ARCHAEOLOGICAL REVIEW COMMITTEE HEARING

THURSDAY, February 1, 2018, at 4:30 PM

**MINUTES OF THE
CITY OF SANTA FE
ARCHAEOLOGICAL REVIEW COMMITTEE HEARING
City Councilors Conference Room
February 1, 2018**

Figure 5. Coronado Road Segment

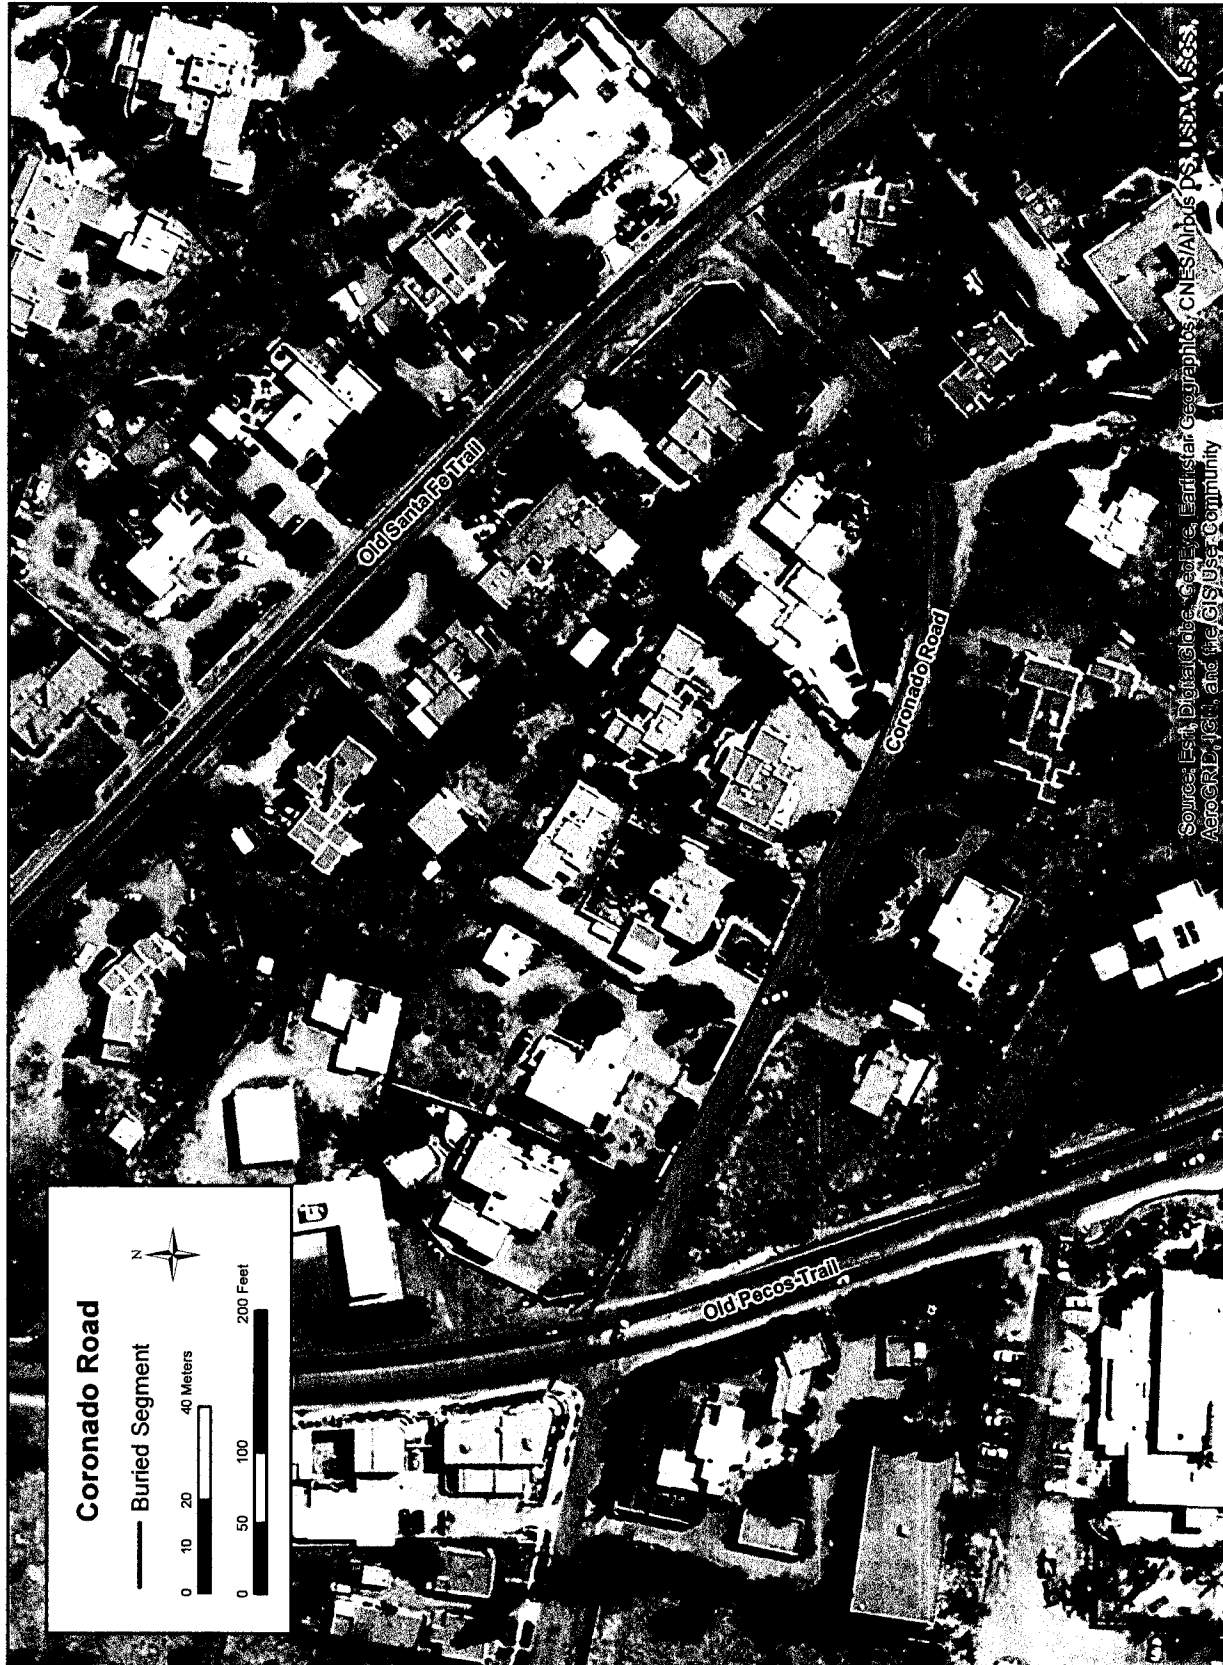
Mr. Pierce, referring to packet page 13, talking about the Coronado Road segment, said the last sentence in Paragraph 2 under Coronado Road, says, "*Several bore hole openings would be required to complete installation along this segment.*" He said there is the same language with all the other segments. He said in some cases where boring was requested and we approved, we have the benefit of knowing exactly where the vaults would be, how big they would be, how deep they would go, how far apart they would be. However, we have none of that detail in the report. He said, "Without knowing that we will at least be able to see something to monitor some small portion of this, I think this is a non starter for me. To be frank, I think that we just don't have enough information to approve this case. And I'm wondering if perhaps you want to take it back and take another stab."

Mr. Pierce asked if they know what type of openings these will be, commenting he describes everything as bore holes, and in some of the other cases, they were a little more specific in terms of vaults and bore holes. He said without this detail, he doesn't know that we are seeing any monitoring of this at all, which is the problem with boring in general, is that it is basically not monitorable at all. He said we have said we would be able to see something in the various openings, and we don't know where those will be, how large they will be. He said it doesn't feel as if there is any archaeology happening here, or there is no guarantee of any archaeology.

Figure 9. Santa Fe High School Segment

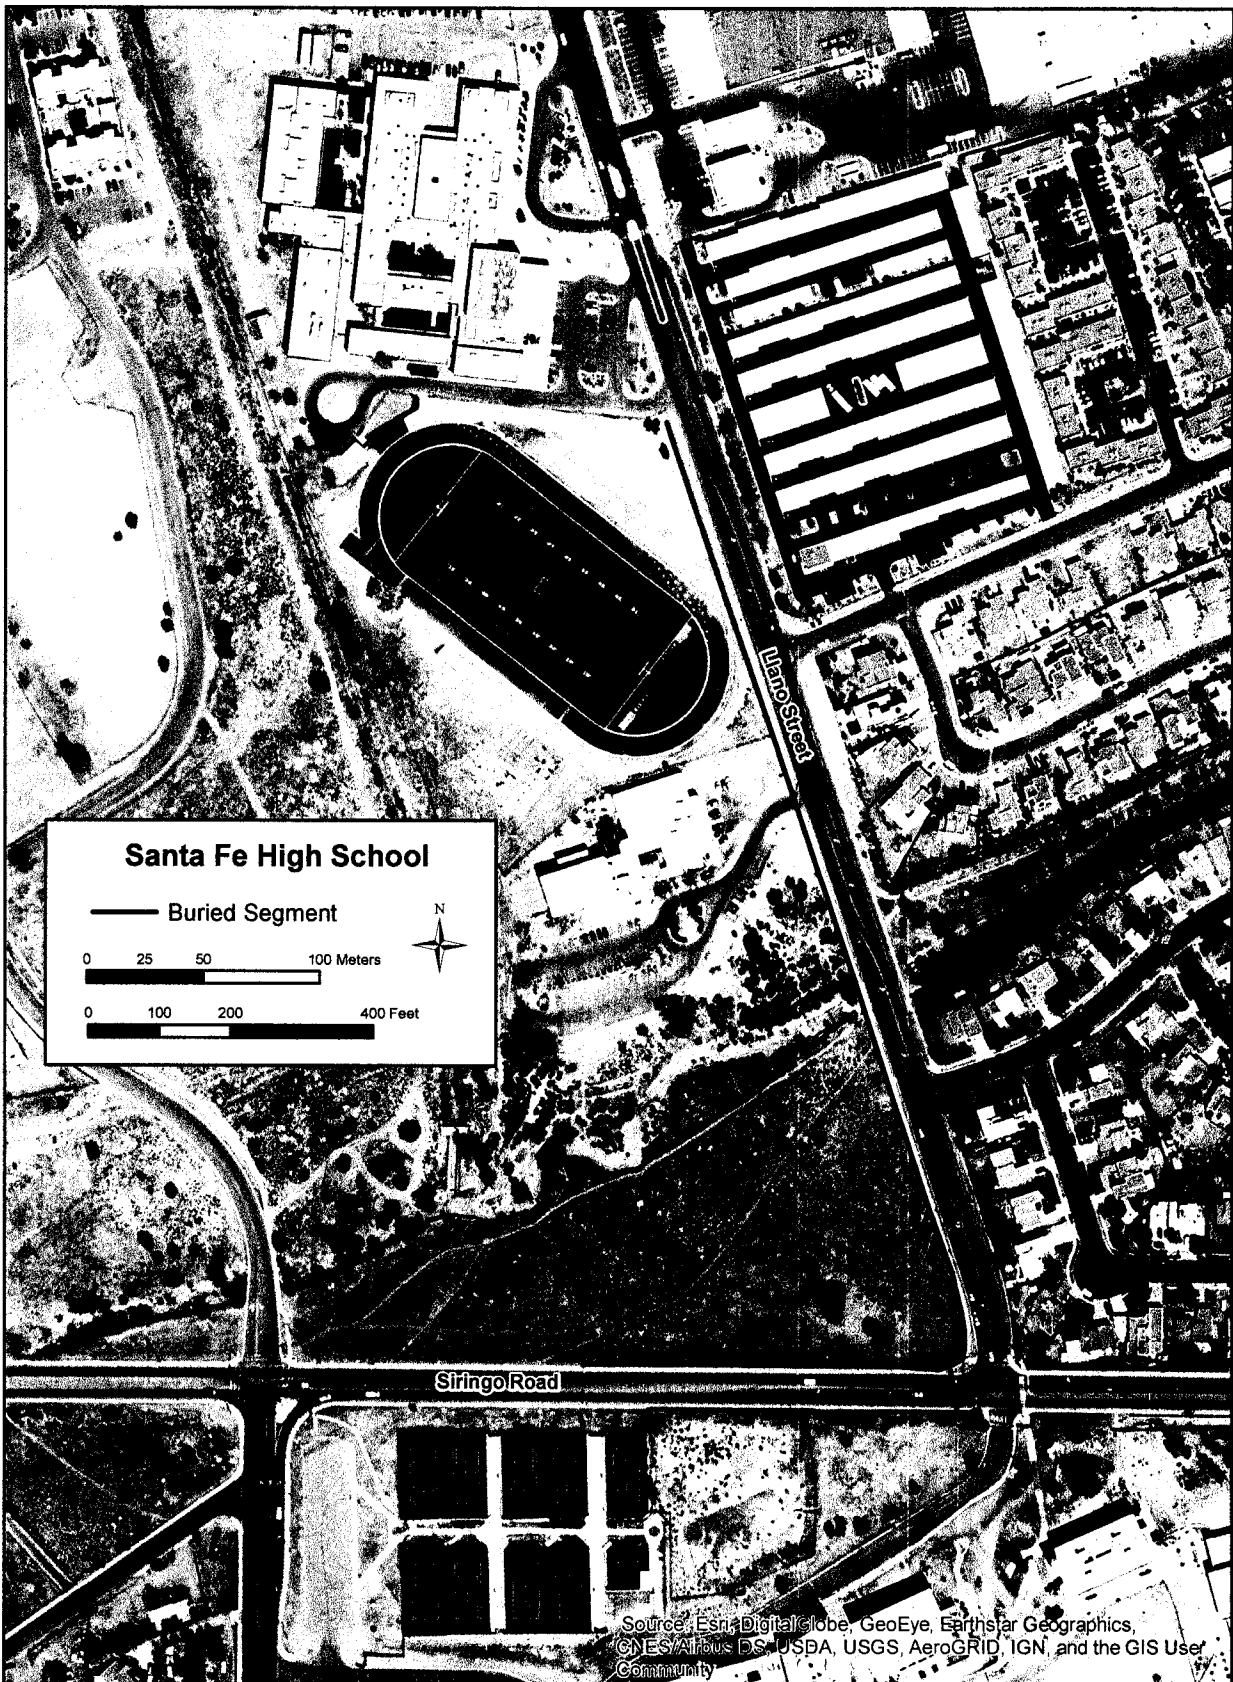
Mr. Pierce continued, thanking Mr. Okun for the color copies. He said, regarding Figure 9, the Santa Fe High segment that goes from Santa Fe High to DeVargas School, he is puzzled as to the reason they are connecting to a school that is no longer there.

Mr. Pierce said the real reason he wanted to refer to Figure 9, is this is a good opportunity to discuss what is appropriate for boring and what should be open trench. He said clearly, nobody wants you to trench across Siringo, "so that little segment, that's a bore, no brainer." However, the rest of it looks to be in mostly in undeveloped ground, so he sees no compelling, public safety reason you would have to do boring there instead of a trench where we actually could see something. He said this is an example, and they need to reevaluate the segments and see where they logically can be broken up into areas that should be bored and areas that can be trenched, and come back to us with that kind of detail.

Mr. Schalipp said as part of what they have to construct to get to the High School, it runs on Siringo, crosses the road, and there is a planned box placement there to ultimately connect to DeVargas. However, until the School District gives Conterra that location as a meet point, we really can't decide where it is going to go.
